January 15, 2026, EFSC Meeting

Item G, Attachment 2

Public Comments on Biglow Canyon Windfarm RFA4 and Proposed Order

Index of comments received **as of January 13, 2026**

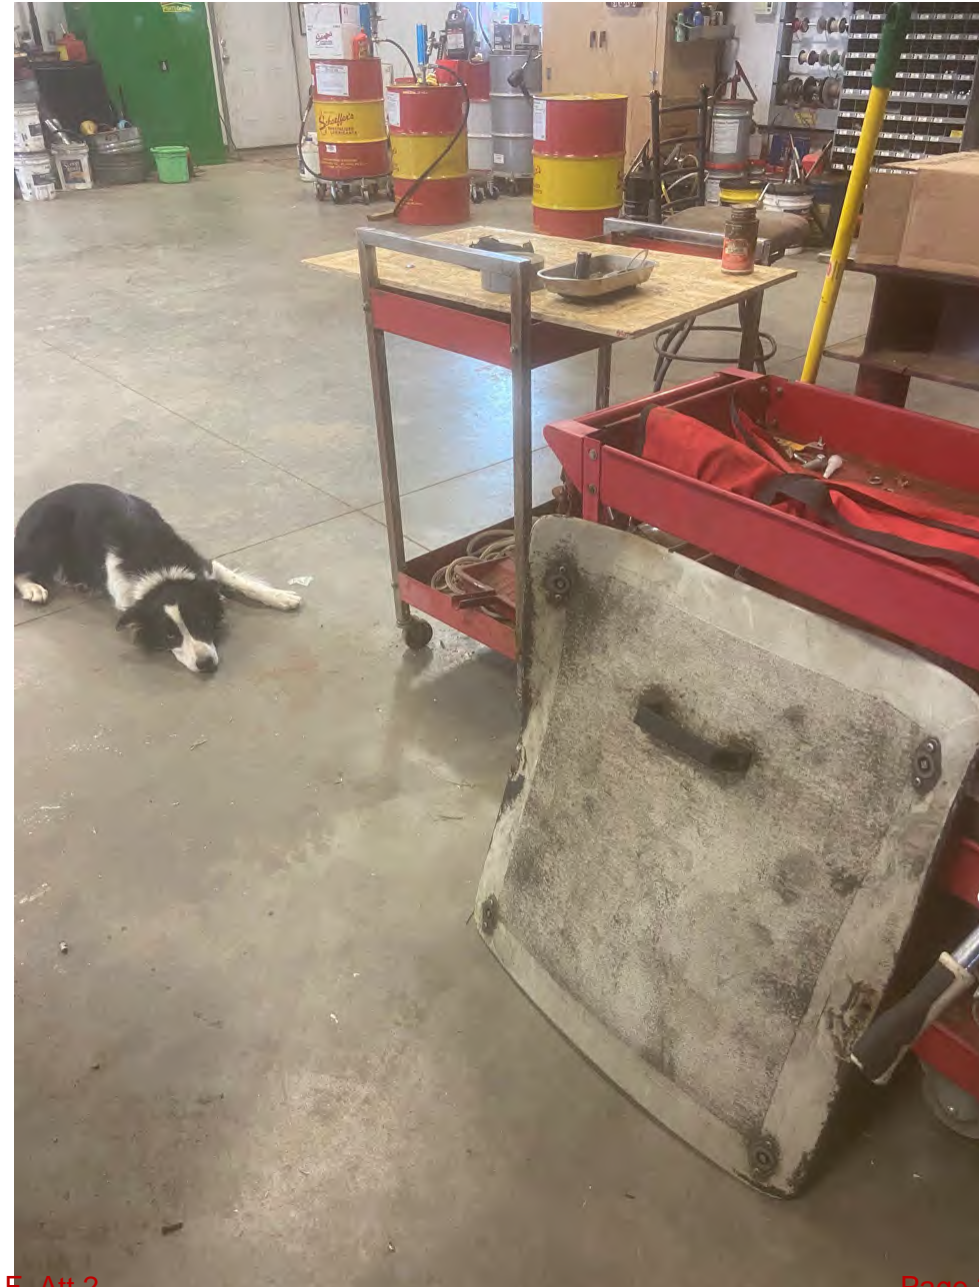
Another missing door.

I found three missing yesterday where we were harvesting. 22, 23, and 25.

See the hole? You can see where it broke away.

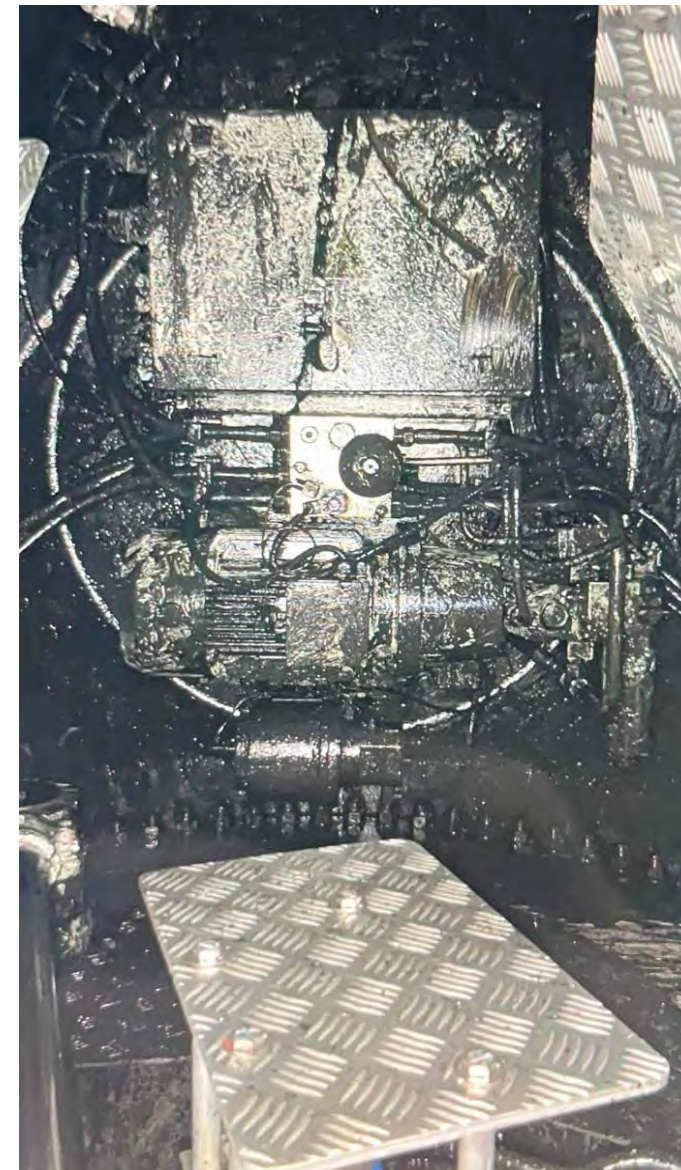
My other worry is fire. These things are oily and greasy inside.

PGE says they can't confirm this is a Biglow tower.

Well, I can.

With our high summer temperatures (111 degrees +), and their over-heating components, it's a fire waiting to happen.

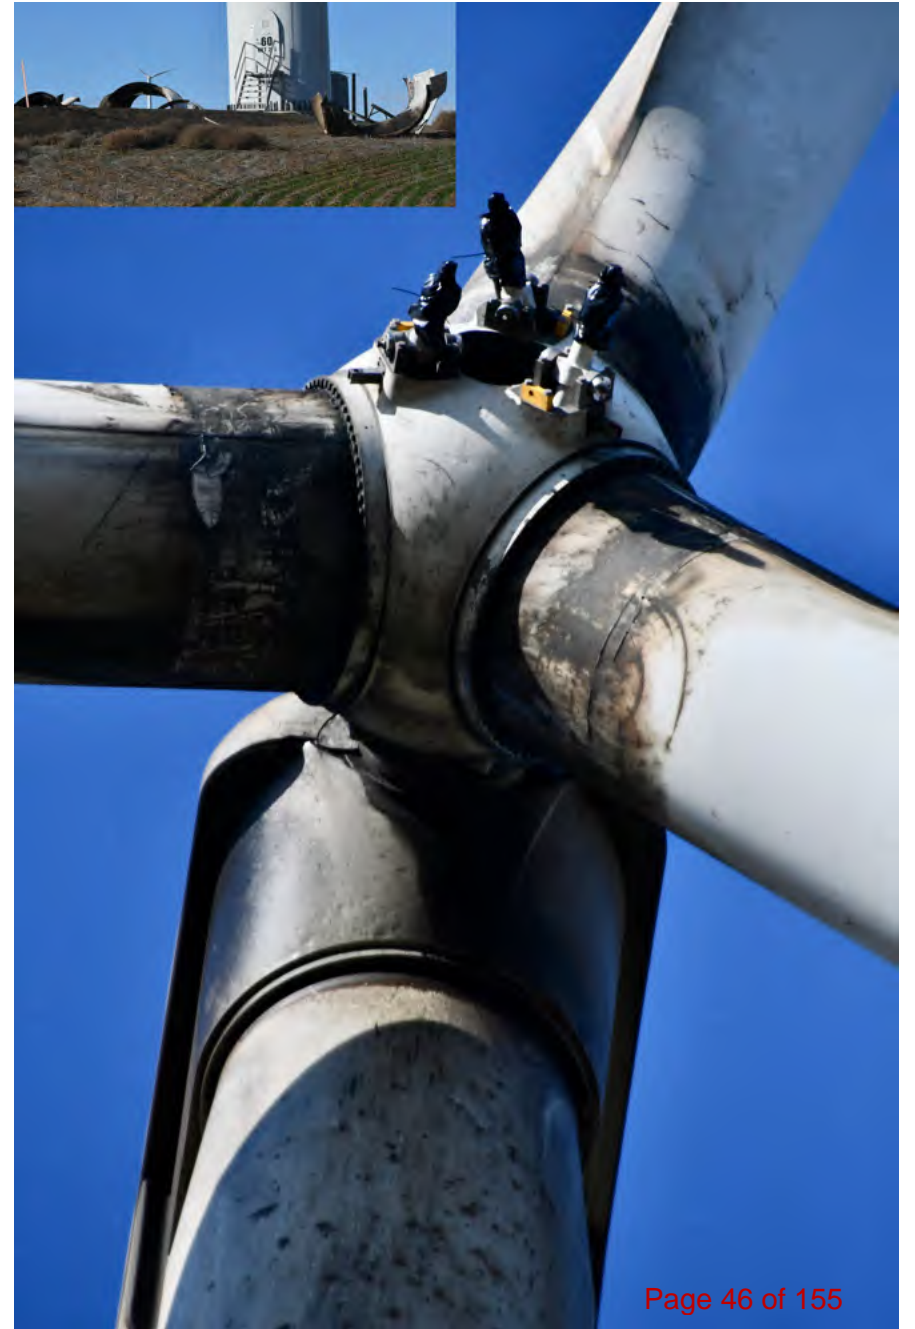
We picked up the 3+ pieces that had dropped in the field and placed them under the tower.

When the blade fell off February 1, 2022, all the pieces were still there!
(You can't see the nose cone in the gully)

I mentioned the nose cone was still down in the gully on a Zoom call this July. They said that was because the farmer told them not to pick it up! *Well, kind of true.* We didn't want them driving through our growing wheat, but they had 6 months before we seeded!
